M.R.253

1984 JEEP  
GRAND WAGONEER  
AND TRUCK

## ENGINE

## ALTITUDE PERFORMANCE ADJUSTMENTS

**Fig. 1 Modifying Low Altitude Model for High Altitude Operation**

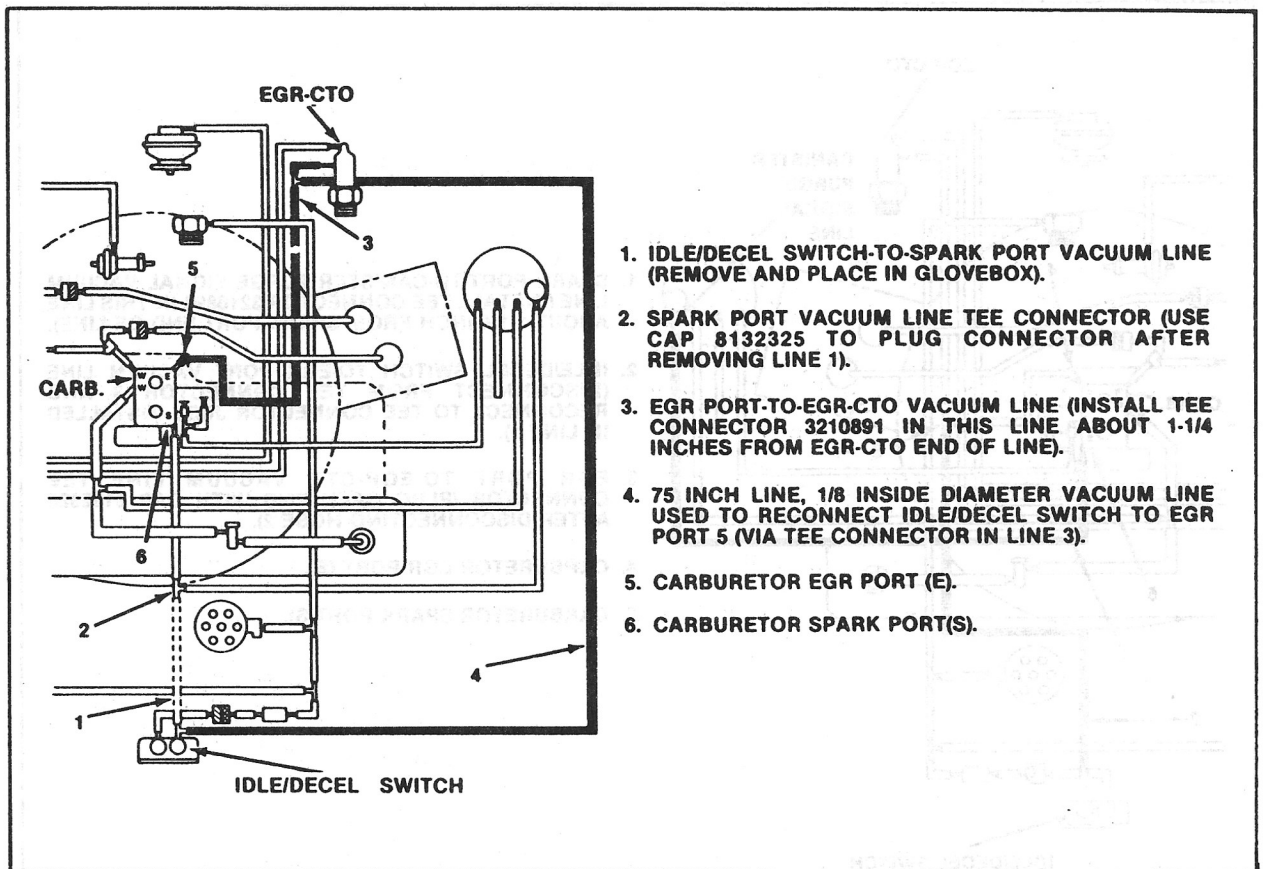
3. Connect the idle/decel switch to the carburetor EGR port as follows (Fig. 1).
  - a. Disconnect vacuum line 1 from the idle/decel switch and from tee connector 2 (Fig.1). Place this line in the glovebox — do not discard it.

- b. Install cap 813 2325 over the open end of tee connector 2.
  - c. Cut and install tee connector 321 0891 in vacuum line 3 (Fig 1). Position the connector about 1-1/4 inches from the EGR-CTO end of the line.

- d. Connect 75-inch long vacuum line 4 to the idle/decel switch and to the tee connector in line 3 (Fig. 1).
4. Advance ignition timing 7° from the setting specified on the original Vehicle Emission Control Information label and reset idle speed to the setting on the same label.

**Fig. 2 Modifying High Altitude Model for Low Altitude Operation**

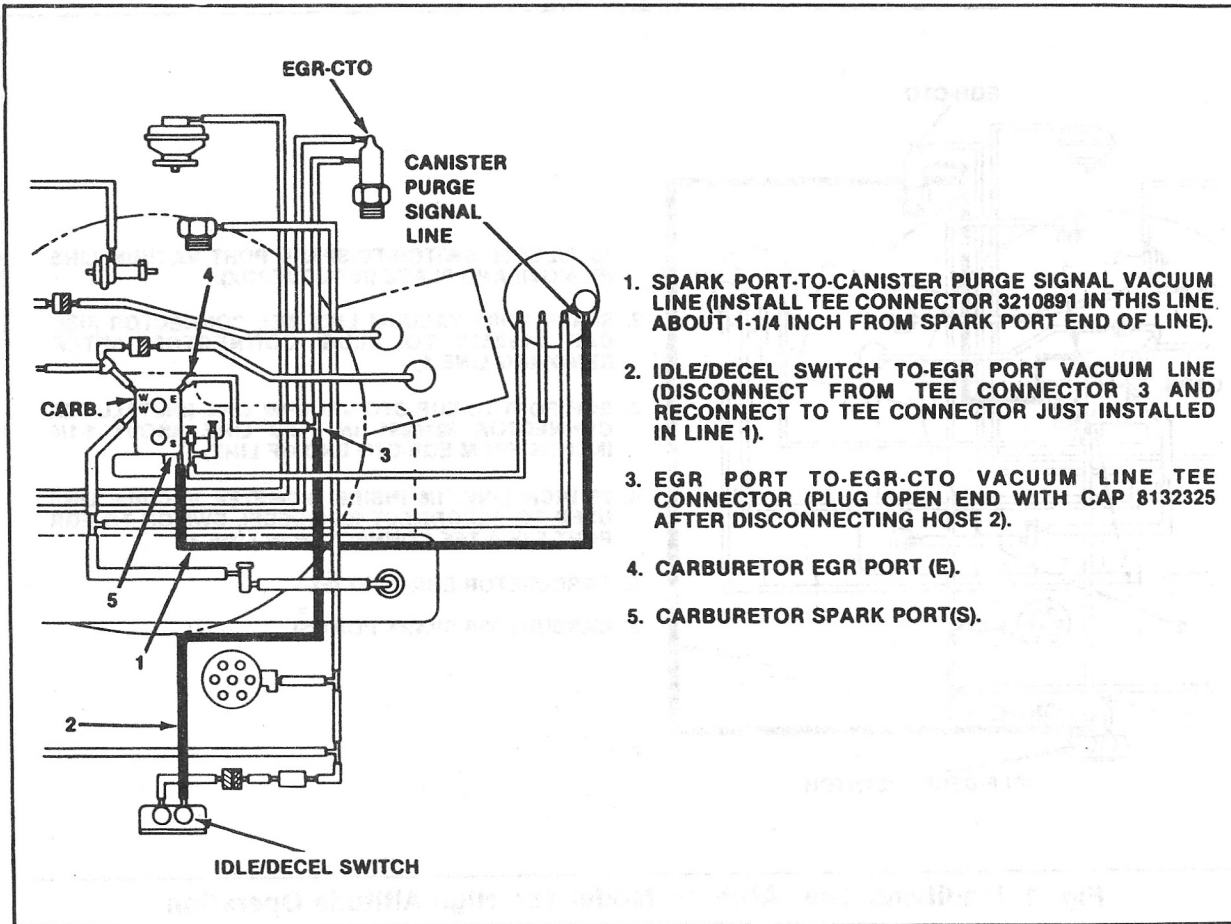
1. Disconnect the black with tracer altitude circuit ground wire from the engine ground screw. Tape the wire to the MCU harness securely and be sure the wire eyelet is completely covered with tape.
2. Connect the idle/decel switch to the carburetor spark port as follows (Fig. 2).
  - a. Cut and install tee connector 321 0891 in vacuum line 1. Position the connector about 1-1/4 inches from the spark port end of the line.
  - b. Disconnect vacuum line 2 from tee connector 3. Then reconnect line 2 to the tee connector just installed in vacuum line 1.
  - c. Plug open end of tee connector 3 with cap 813 2325.
3. Retard ignition timing 7° from the setting specified on the original Vehicle Emission Control Information label and reset idle speed to the setting on the same label.
4. Install Vehicle Emission Control Information Update label, 8983 100 010, next to the original label.
